**WATTS BAR NUCLEAR PLANT (WBN) UNIT 1 - GENERIC LETTER 2004-02
- REQUEST FOR ADDITIONAL INFORMATION REGARDING THE NUCLEAR
REGULATORY COMMISSION STAFF AUDIT ON THE CONTAINMENT SUMP
MODIFICATIONS (TAC NO. MC4730)**

**WATTS BAR NUCLEAR PLANT (WBN) UNIT 1
GENERIC LETTER 2004-02
RESPONSE TO REQUEST FOR ADDITIONAL INFORMATION
NRC AUDIT OF CONTAINMENT SUMP MODIFICATIONS**

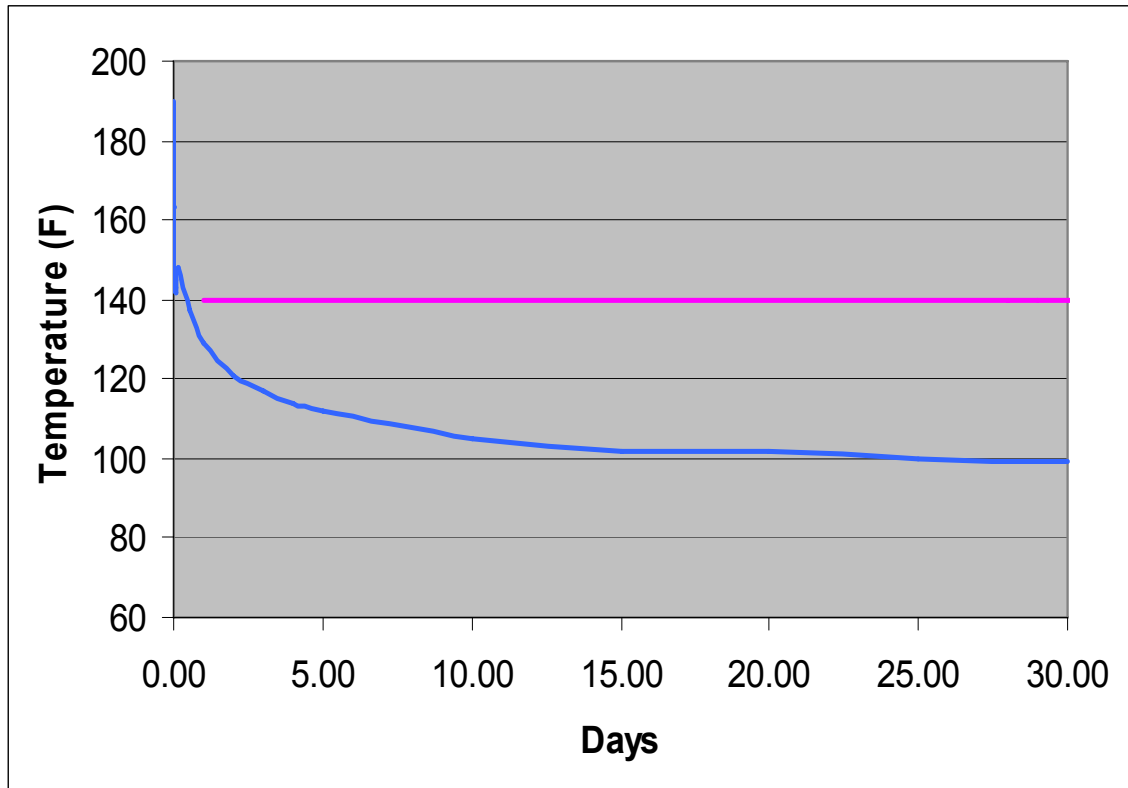
If possible, provide the containment pool temperatures as a function of time during the emergency core cooling system (ECCS) mission time for the limiting combination of conditions that would produce (i) the highest pool temperatures with time, and (ii) the lowest pool temperatures with time.

The figure above shows the sump temperature for the limiting large break LOCA. The analysis is based on one train of ECCS and containment spray which minimizes containment heat removal. The analysis also assumed an ultimate heat sink temperature of 88 degrees Fahrenheit (F) which is higher than the current technical specification limit of 85 degrees F. It also assumes that river stays at this temperature for the entire 30 day period. This is a very conservative assumption. It should be noted that TVA has submitted a Proposed License Amendment Request (WBN-TS-06-09) dated May 8, 2006, to increase the design basis ultimate heat sink temperature to 88 degrees F. The RWST temperature was
